## Access Compliance Report Public Rights-of-Way (Curb Ramps)

Intersection ID: 49689 Main Street: ALEXANDRA\_ALLEY\_DR Cross Street: SHARON\_HILLS\_RD Location: E

ADA ID: 50B118BE81FD Ramp Type: PerpDiag Initial Pass/Fail: Fail Overall Compliance: No Severity Score: 33.75

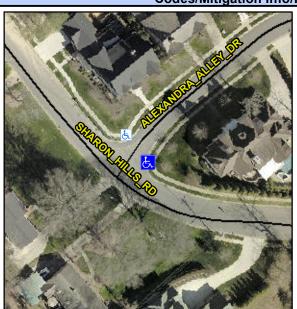
Not Found, R304.5.1, R304.5.3

Remove & Replace Curb Ramp With Two New Directional Ramps or Equivalent.
